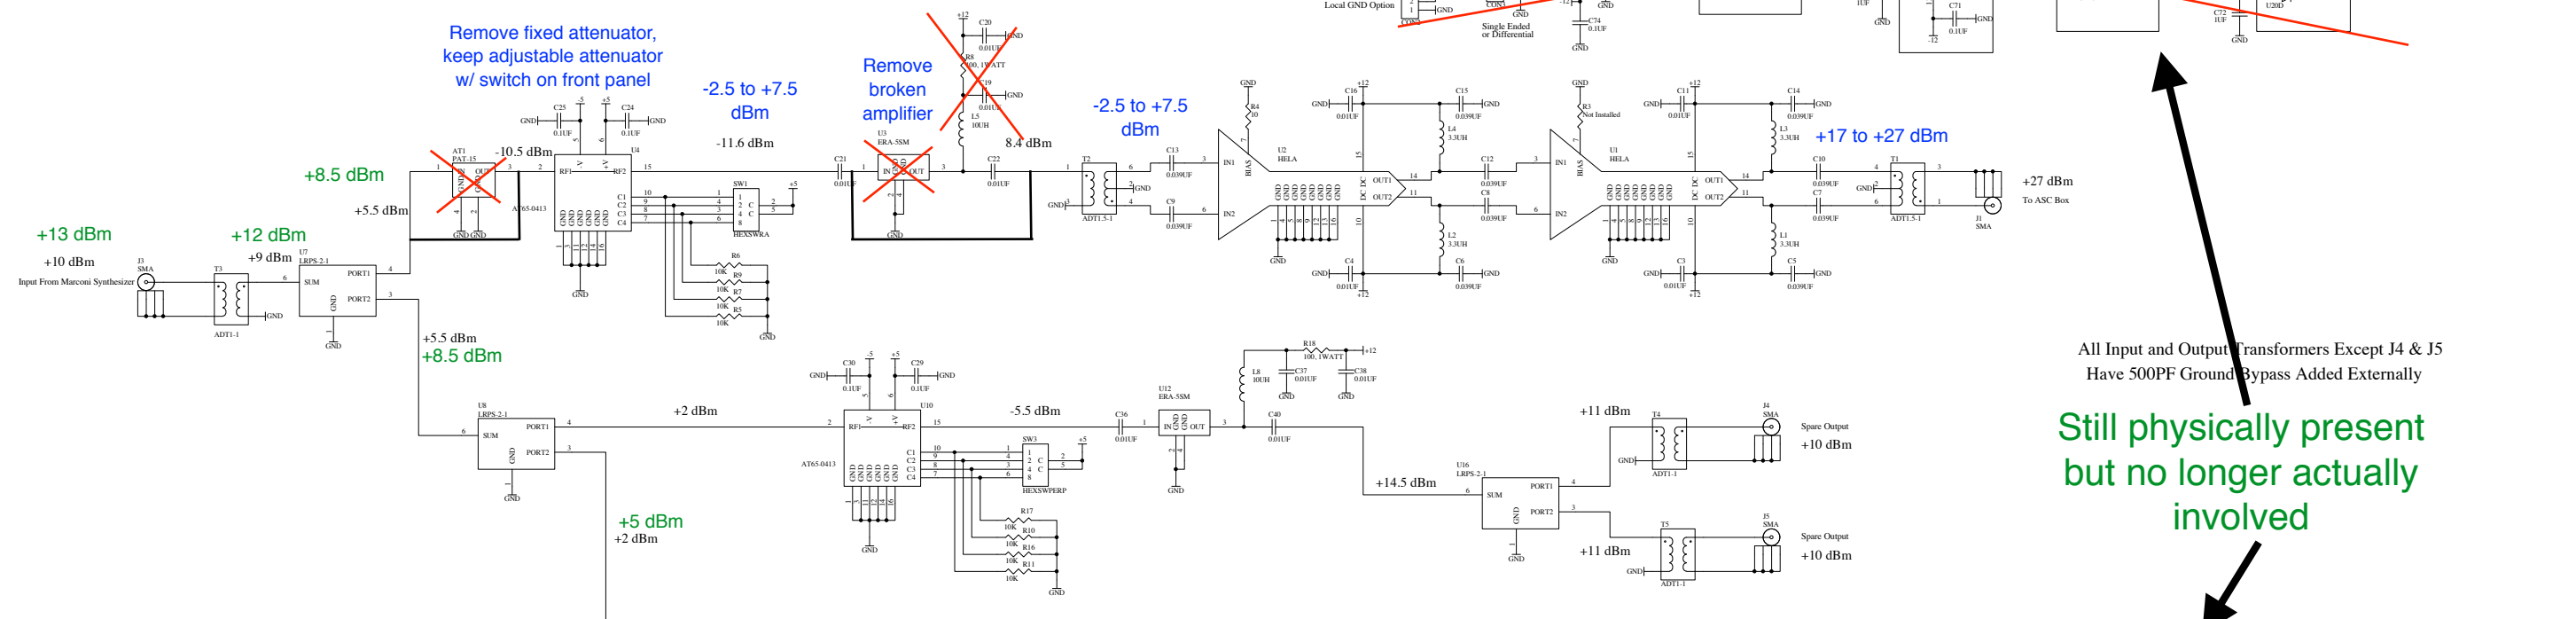
- Changes and errors:**
1. The J11 input ground selection jumper is not useful.
  2. The footprint for U13 is incorrect on the PCB
  3. Selection for ATXU13 should be via zero ohm resistors
  4. 500 pF caps should be added to all RF inputs and outputs
  5. HELA 10 amplifiers are added to all RF inputs and outputs
  6. Remove L16 and C79
  7. Need test points on the band pass filter to facilitate tuning
  8. Add a block on PCB to write what the attenuator settings are

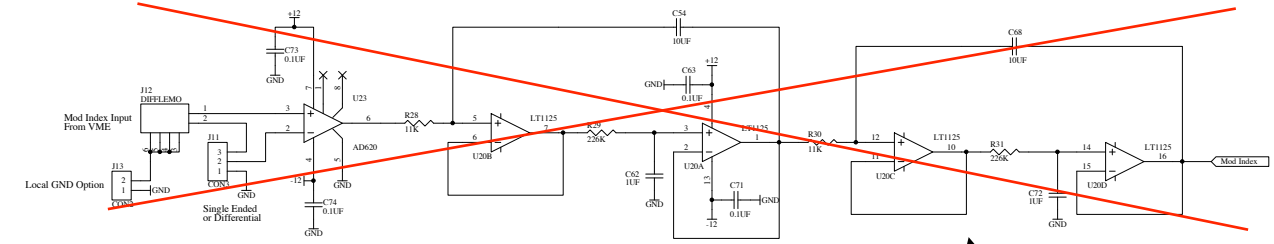
All Input and Output Transformers Except J4 & J5  
Have 500PF Ground Bypass Added Externally

Still physically present  
but no longer actually  
involved
